INITIAL FIRE SAFETY INSPECTION REPORT

Nafa Apparels Ltd. 2 (Extension)

RSC ID: 24853

Date: 10-Sep-2024

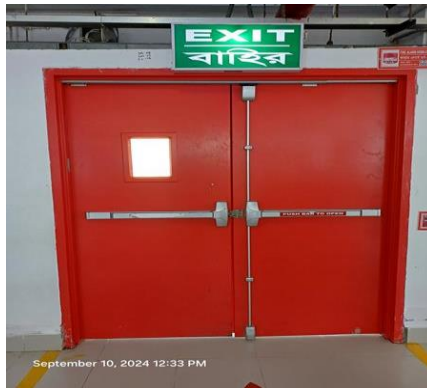
SI No.	Category	Findings	Required Action	Remediation Time Frame
F-01	Fire Rated Construction	6-Storied New RCC Building-1: The factory has installed fire rated doors to separate the storerooms on 3rd, 4th and 5th floor. The datasheets & certificates of installed fire-rated doors will be verified during the next inspection.	The factory shall provide datasheets and certificates of installed fire rated doors and their accessories to verify during the next inspection. If fire rated doors are required to be held open for functional reasons, provide automatic closing devices tied to the fire alarm system.	Within 3 months

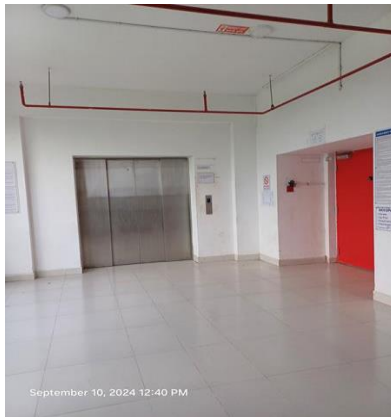
F-03	Fire Rated Construction	6-Storied New RCC Building-1: Unsealed penetrations were observed in between the production floor and electrical riser shaft on all floors. Unsealed penetrations and openings are located in the fire rated floor/ceiling assemblies due to electrical cable riser on basement to ground floor.	Seal all penetrations and openings in floor/ceiling assemblies by a listed through-penetration fire stop system tested in accordance with ASTM E814 or approved alternative standard to maintain minimum 3-hr. fire resistance rating. Installation shall be as per manufacturer published installation guideline and the certification authority's design criteria to ensure the required fire-rating. Or, Provide a minimum 2-hr fire rated shaft to separate the penetration from each floor if required.	Within 3 months

F-08

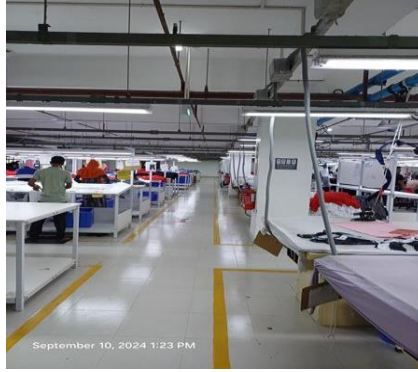
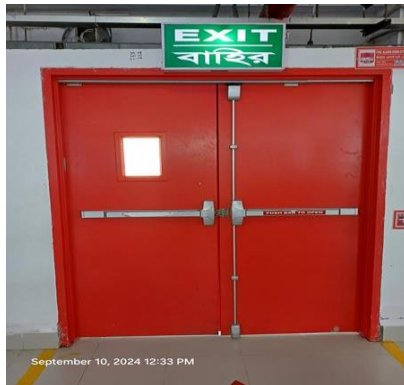
6-Storied New RCC Building-1:
The factory has installed fire rated doors for exit stair separation on all floors for all stairs. The datasheets & certificates of installed fire-rated doors will be verified during the next inspection.

The factory shall provide datasheets and certificates of installed fire rated doors and their accessories to verify during the next inspection.

If fire rated doors are required to be held open for functional reasons, provide automatic closing devices tied to the fire alarm system.

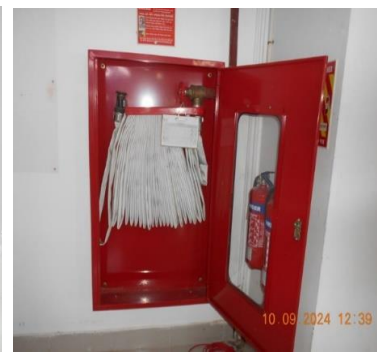
F-18	Inspection, Testing & Maintenance (Fire)	Inspection, testing, and maintenance for the fire pump is not in accordance with NFPA 20, 25 and RSC Technical Guideline (Standard).	Inspect, test and maintain the fire pump in accordance with NFPA 20, 25 and RSC Technical Guideline (Standard) and keep written records on-site.	Within 1 month (after installation)
F-19	Inspection, Testing & Maintenance (Fire)	Inspection, testing, and maintenance for the Standpipe system is not in accordance with NFPA 14, 25 and RSC Technical Guideline (Standard).	Inspect, test and maintain the standpipe system in accordance with NFPA 14, 25 and RSC Technical Guideline (Standard) and keep written records on-site.	Within 1 month (after installation)
F-20	Inspection, Testing & Maintenance (Fire)	Inspection, testing, and maintenance for the Sprinkler system is not in accordance with NFPA 13, 25 and RSC Technical Guideline (Standard).	Inspect, test and maintain the Sprinkler system in accordance with NFPA 13, 25 and RSC Technical Guideline (Standard) and keep written records on-site.	Within 1 month (after installation)
